Title - Sujet Col-12 Contaminated Soil Disposal	
Solicitation No. - N° de l'invitation EZ113-151591/A	Amendment No. - N° modif. 002
Client Reference No. - N° de référence du client	Date 2015-01-13
GETS Reference No. - N° de référence de SEAG PW-\$PWY-020-7400	
File No. - N° de dossier PWY-4-37233 (020)	CCC No./N° CCC - FMS No./N° VME
Solicitation Closes - L'invitation prend fin at - à 02:00 PM on - le 2015-01-15	Time Zone Fuseau horaire Pacific Standard Time PST
F.O.B. - F.A.B. Plant-Usine: <input type="checkbox"/> Destination: <input checked="" type="checkbox"/> Other-Autre: <input type="checkbox"/>	
Address Enquiries to: - Adresser toutes questions à: Ly, Ronny(PWY)	Buyer Id - Id de l'acheteur pwy020
Telephone No. - N° de téléphone (604) 666-0043 ( )	FAX No. - N° de FAX (604) 775-6633
Destination - of Goods, Services, and Construction: Destination - des biens, services et construction: DND - Colwood Site 12 - Colwood, BC

This Amendment 002, Addendum 001 is raised to provide clarification to questions received from prospective bidders.

**TOPOGRAPHIC SURVEY**

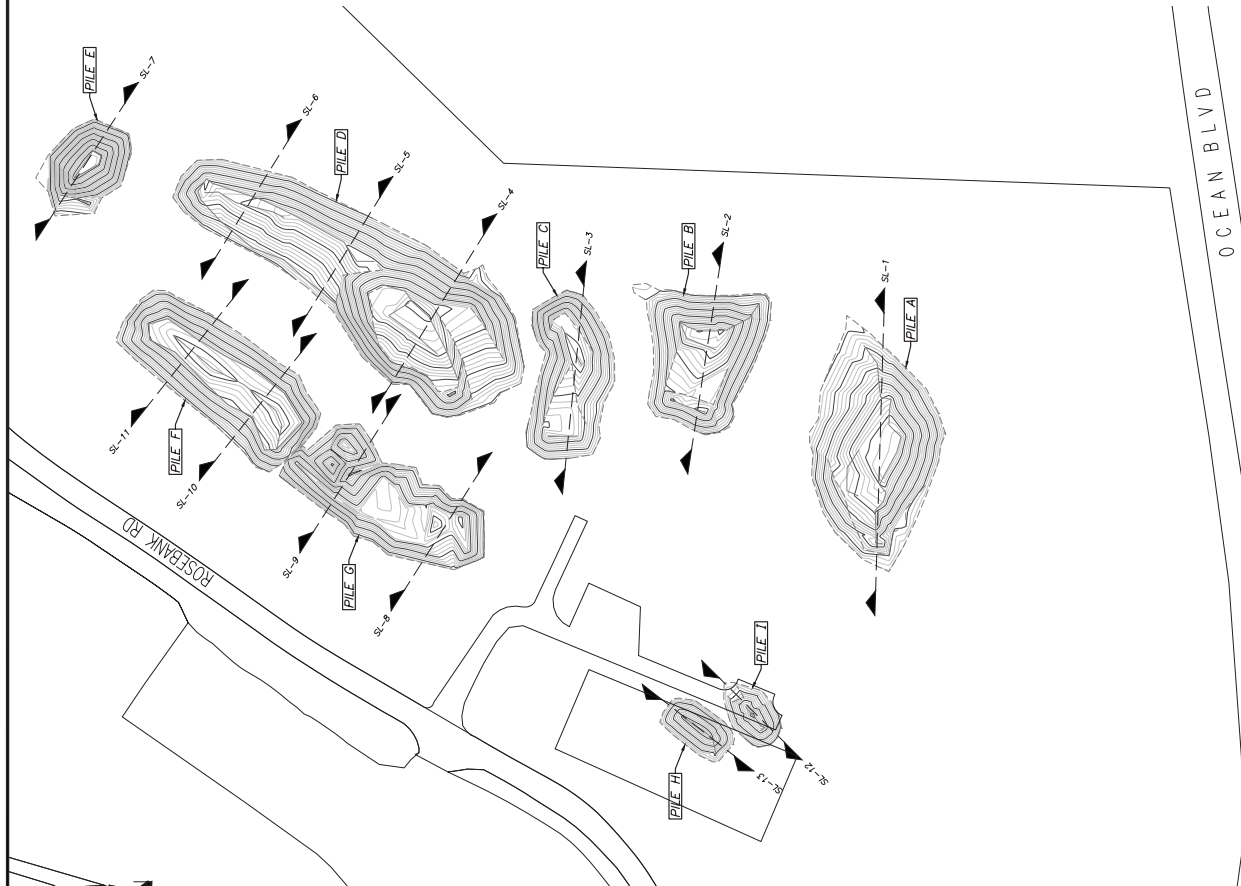
Upon review of the tender documents and amendment 1 and 2, QMLP is unable to correlate the 10,674 metric tonnes of contaminated soil from line item 6 to stockpile quantities provided in SLR's report. Please clarify which specific stockpile IDs will be loaded, transported and disposed of under this tender.

The total tonnage of CL+ material to be disposed of is restricted to 10,674 tonnes under this project. The work stated in the Specs requires partial removal of the CL+ stockpiles which will include all of SP-3 (Pile D in the attached) and most of SP-1 (Pile E in the attached).
